### **I-405, SR520 to SR522 Stage 1 (Kirkland Stage 1)**

**Table of Contents**  
**I-405, SR520 to SR522 Stage 1**  
**Design Deviation Papers**

### Design Deviation #1

NB I-405 Superelevation Transition Location

Limited Access Design Deviation  
Exhibit 7  
Alt D – Modify SPUI  
Build New Ramp Within Existing Limited Access

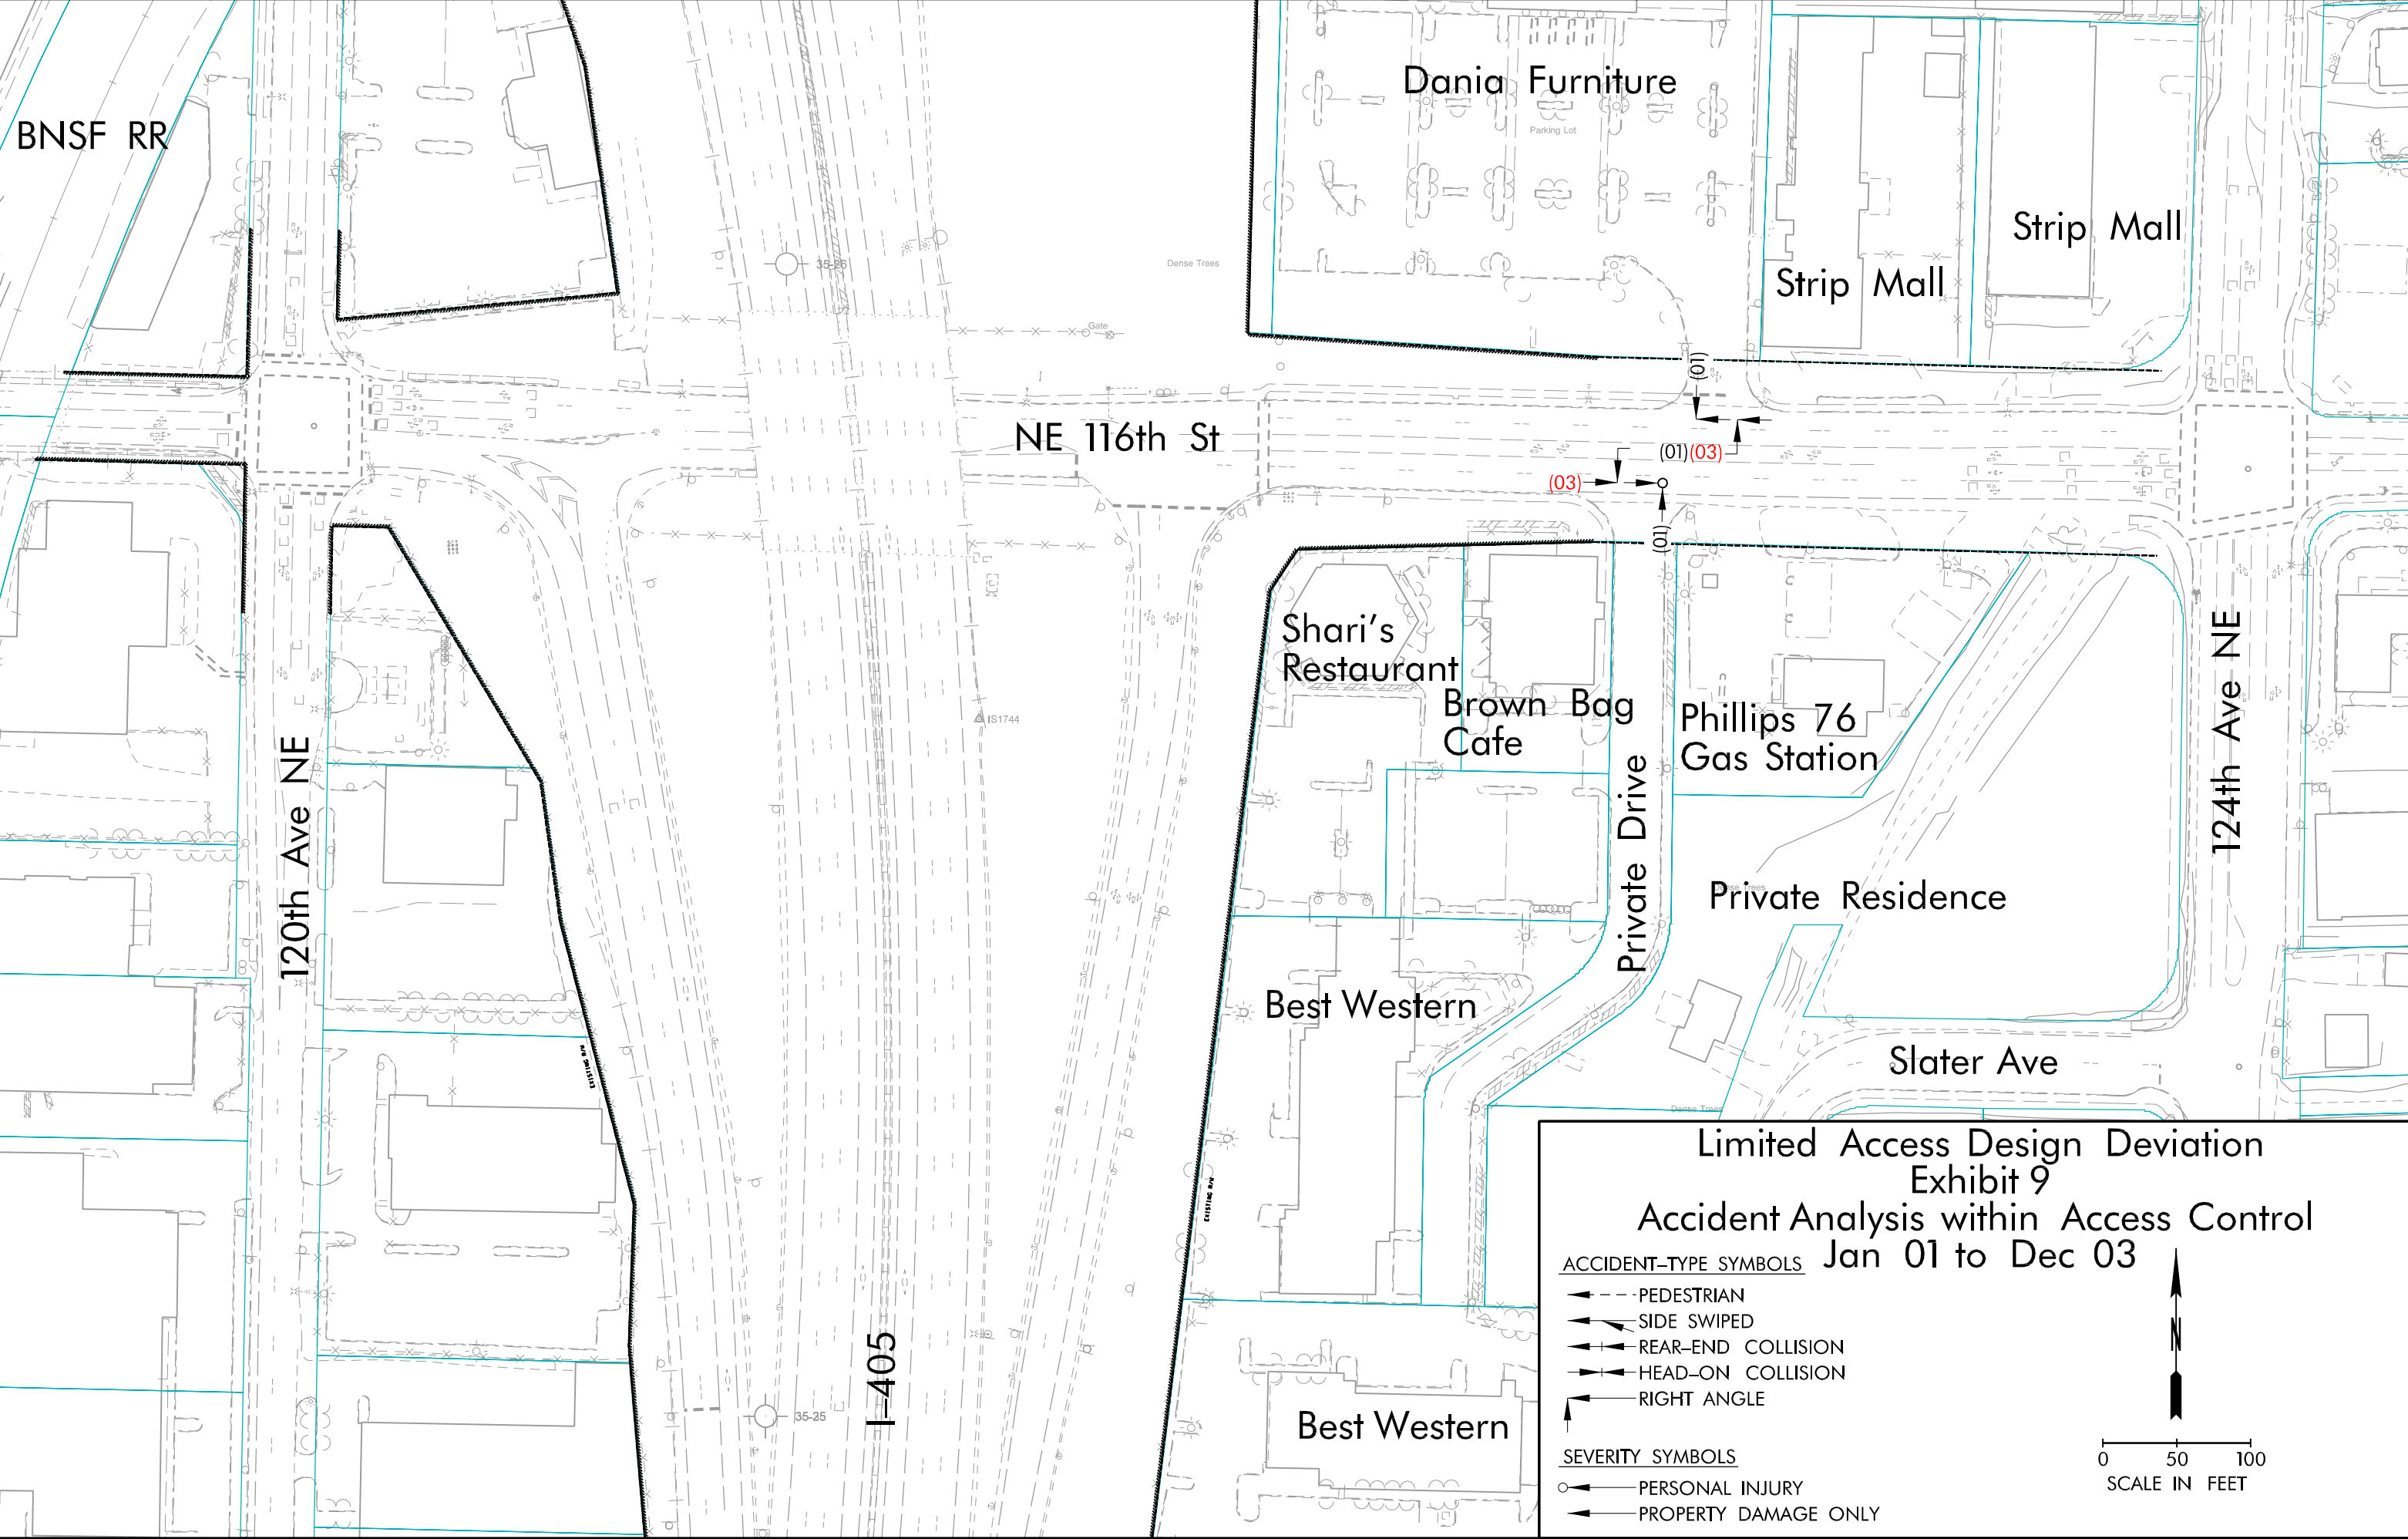
*Alternative D Modify SPUI-Build New Ramp within Existing Limited Access (Exhibit 7) –* This alternative will replace the existing half-diamond interchange with a tight half-SPUI interchange. The tighter half-SPUI ramp design would situate the reference point for limited access measurement in the same location as the existing configuration, eliminating the need to purchase additional access control. The radius for the left turning vehicles is the minimum necessary to meet the design speed through the SPUI (160 foot radius for a 25 mph design speed). The right turn pocket needs a 35 foot radius to match the limited access reference point, which is the design standard for a passenger vehicle. The right turn pocket would be widened and tapered to allow a WB-50 truck to complete the turn, though a WB-67 truck would encroach into the second lane to complete the turning movement.

Squeezing the SPUI ramp into the existing limited access area is not an optimal design for the NB off ramp. In order to build a ramp without increasing the span length of the bridge beyond its current limit, the storage length on the ramps would need to be decreased. Based on traffic models of design year (2030) conditions, this ramp configuration would not provide sufficient storage length for left turning vehicles, while queuing in the right turn lane could interfere with the operation of the SPUI. Increasing the span length of the bridge to increase the ramp storage length results in inefficiencies in the structure type and depth, an unpleasant appearance for the interchange, and the potential for pedestrian discomfort with the offset bridge abutments. Both the NB and SB bridges over NE 116<sup>th</sup> St. would need to be lengthened to meet the Context Sensitive Solutions (CSS) guidelines for the corridor. The total cost of lengthening the bridge span is approximately \$1 Million, including soft costs, inflation and a contingency.

Tightening the half-SPUI ramps to remain within the existing limited access (Alternative D, Exhibit 7) would align the measurement points for the proposed and existing limited access in the same place. The tighter half-SPUI ramp design would eliminate the need to purchase additional access control. This alternative was not selected because in order to provide sufficient storage on the off-ramp the NB bridge would have to be lengthened, increasing bridge cost significantly and degrading the operations of the interchange significantly. This alternative was approximately \$1 million.

Limited Access Design Deviation  
Exhibit 9  
Accident Analysis within Access Control  
Jan 01 to Dec 03

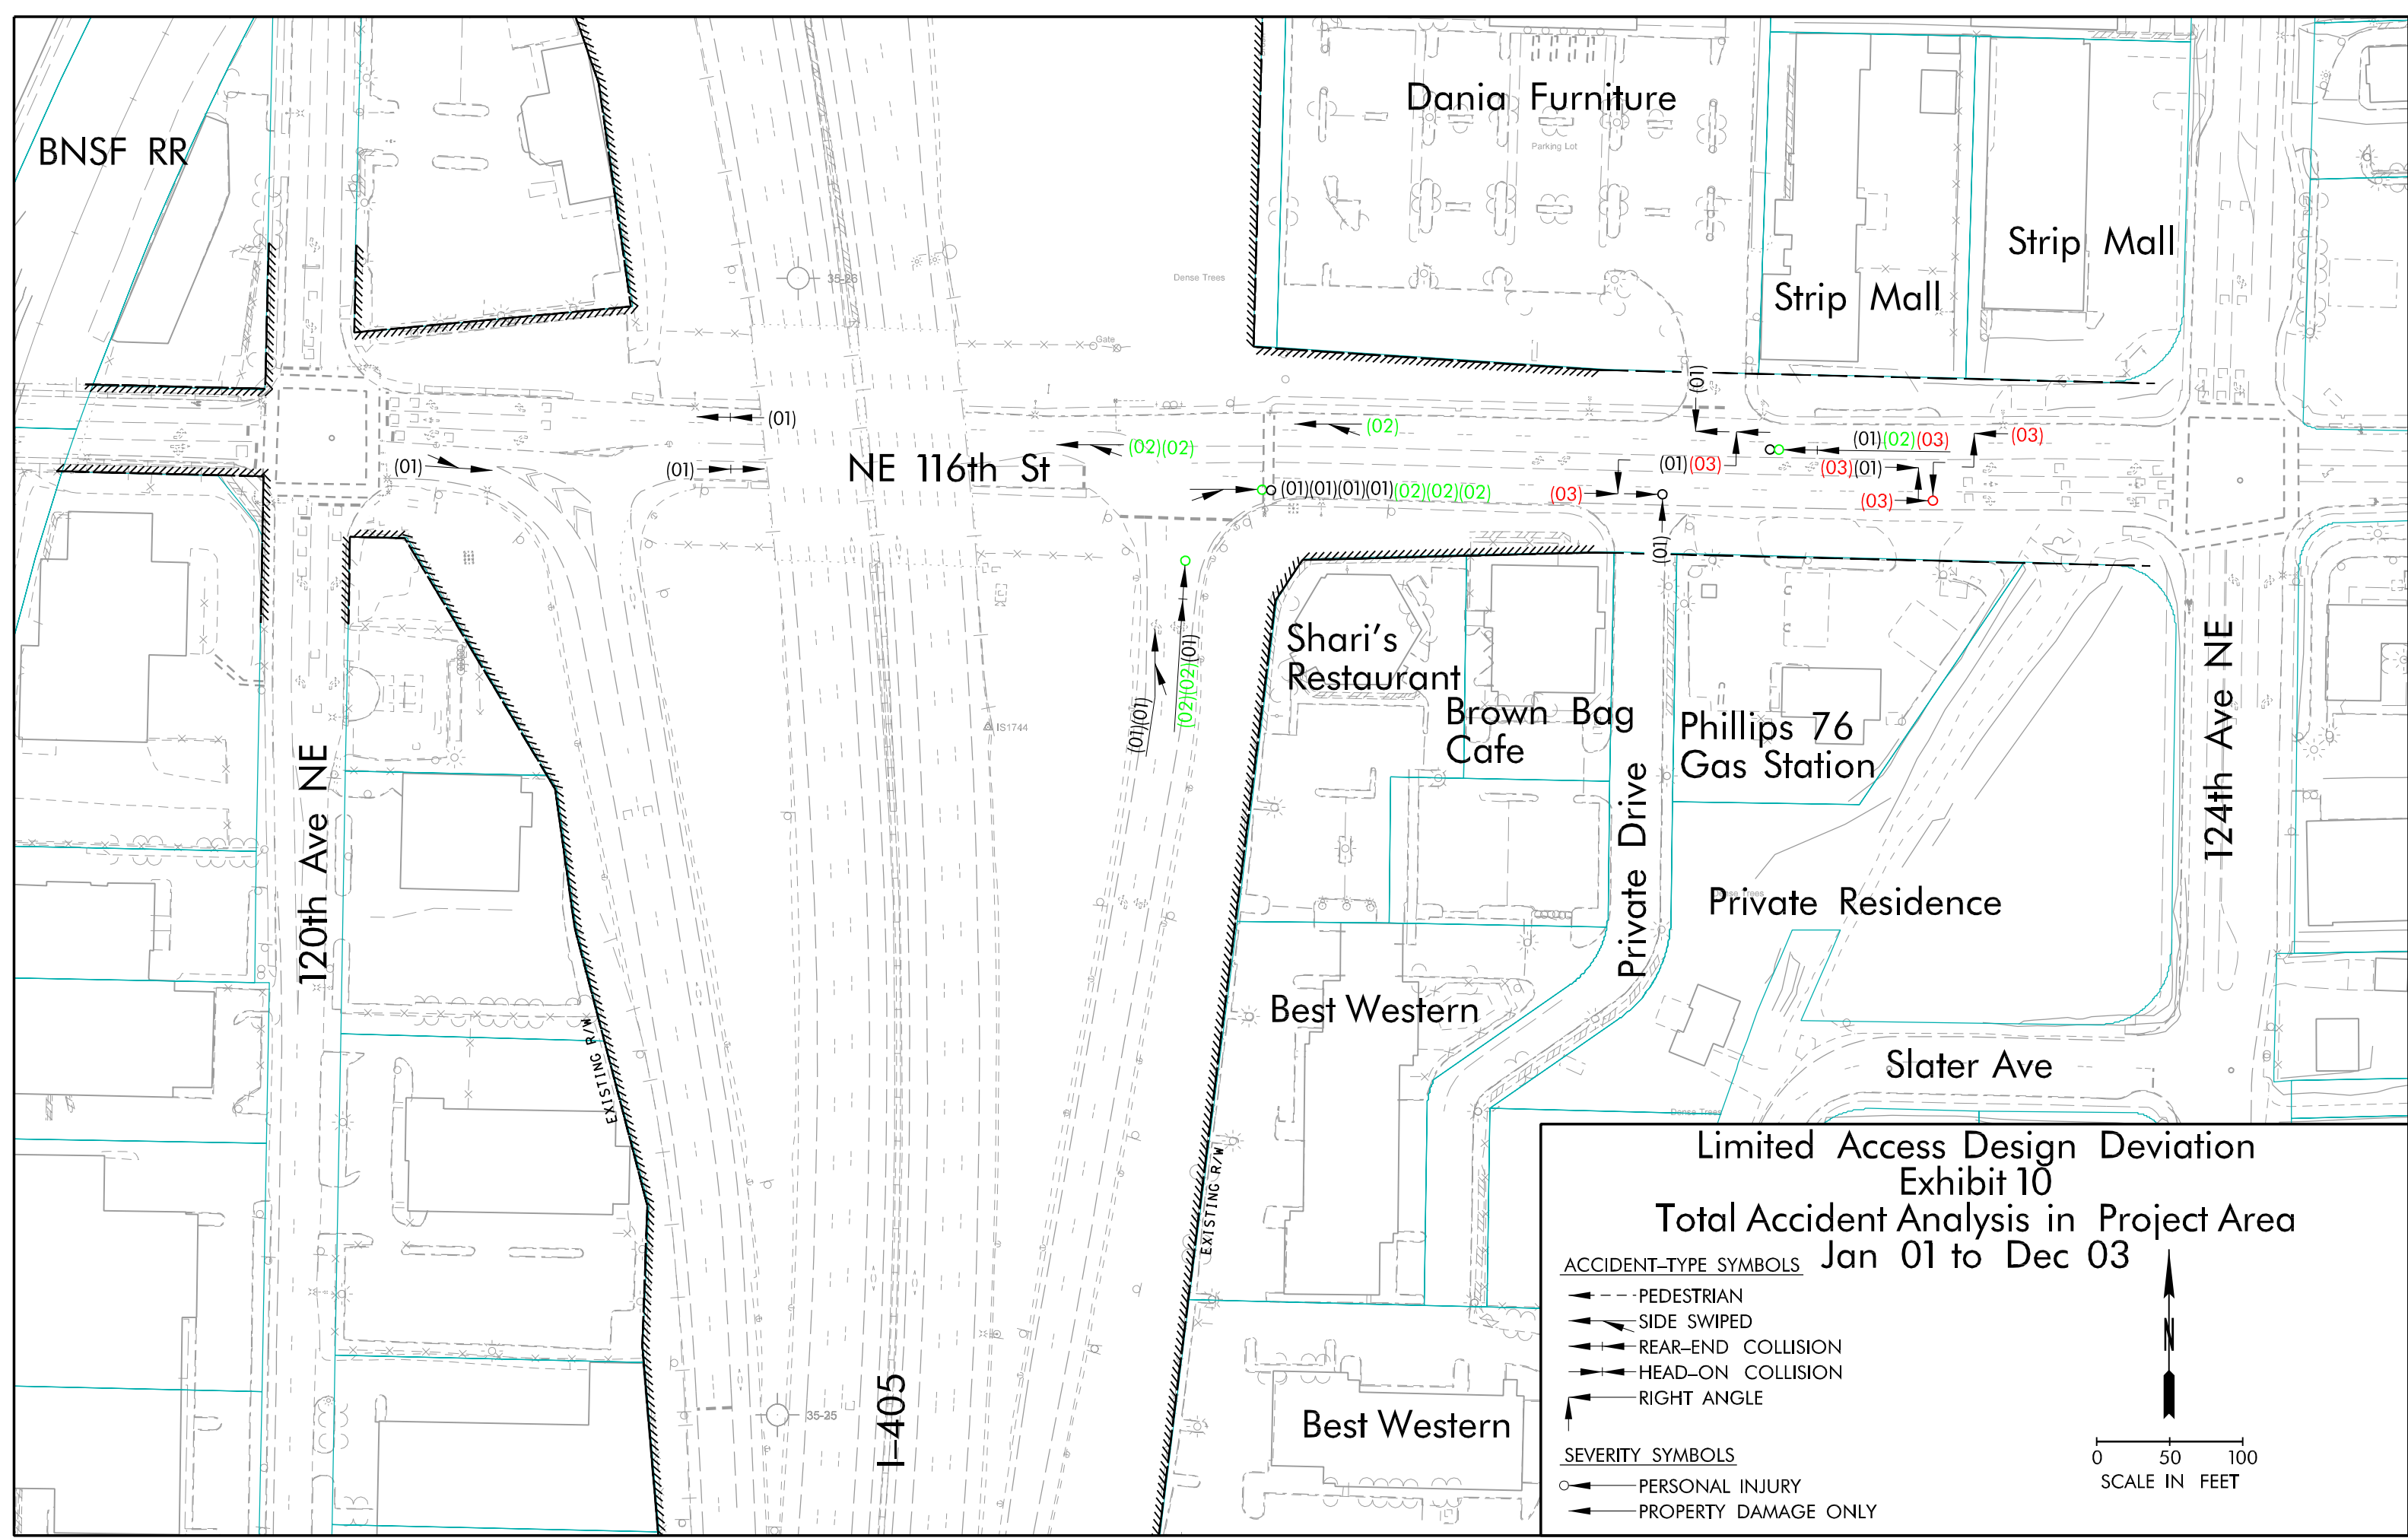
- The accident data furnished by the City of Kirkland supports this alternative with its limited modifications to the existing driveways and channelization. Exhibit 9 shows the five accidents within the area of limited access discussion including the Dania and the private driveway. Four of the accidents, including one injury, were associated with vehicles making lefts turn movements at either Dania or the private access driveway. The fifth accident in this area was a vehicle turning right out of the Dania driveway. It is the policy of NW Region Access Management to further control a driveway if five (5) left turning accidents occur in a three year span, including at least one each year. Based on that standard, none of the existing driveways qualify for further control. Dania and the shared access driveway each had one accident in 2001, none in 2002 and one in 2003.
